From: Bailey, Heather
Sent: Friday, September 13, 2019 8:53 AM
To: 'Vaughn Brandt'; Mark Schmidt; Van Berkel, Adrian
Cc: Heiser-Ertel, Lauren
Subject: RE: 1314 Jenifer Updated Drawings
Attachments: 56712 - 1314 Jenifer COA 9-13-19.pdf

ALTERATIONS TO
E VAUGHN BRANDT RESIDENCE
 1314 JENIFER ST, MADISON, WI 53703

EXTERIOR ELEVATIONS
 8.1

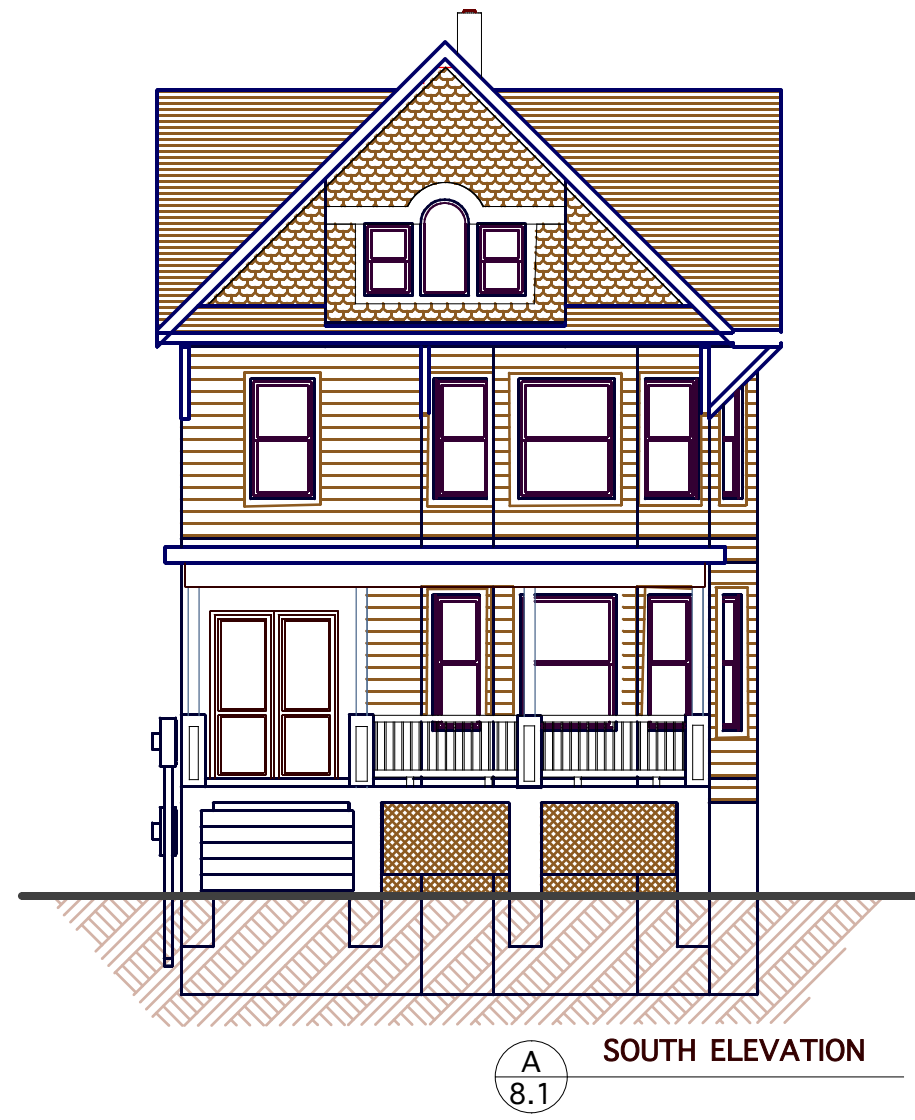
In talking with Adrian, he had concerns about how the roofing on the rear covered porch was terminated. Please reach out to him to schedule your final inspection.

1. On the West side of the addition by the fence, the lower part that was drawn as stone is actually a fine gravel surface texture on the bottom. The notes from Landmarks were:

2. Definitely keeping the decorative brackets. We'll add those to the drawing.

3. There is no window in the large opening, though I see in the drawings there is a glass like texture illustrated, which needs to be removed.

4. The skylights have a symbol from the window schedule, which was used in a previous permit application to clarify glazing to meet natural light requirements. We can remove those from this drawing.

5. To the right of the door there is not a sidelight, I can see how the drawing characterizes that to be misleading. The door is trimmed in a standard 3" brick molding on all sides.

For the bump out that is angled out to cover the curb, that runs the width of the concrete driveway to keep moisture from running in behind the curb. Landmarks approved the bump out, but I am not certain what trim detail you are expecting.

One question: Can the apron board on the bump out be clad in green metal, with siding coming down the vertical wall to it?

In looking over the plans, I think that you've addressed all of the conditions from the Landmarks Commission. I am attaching your COA and including the updated plans in the file.
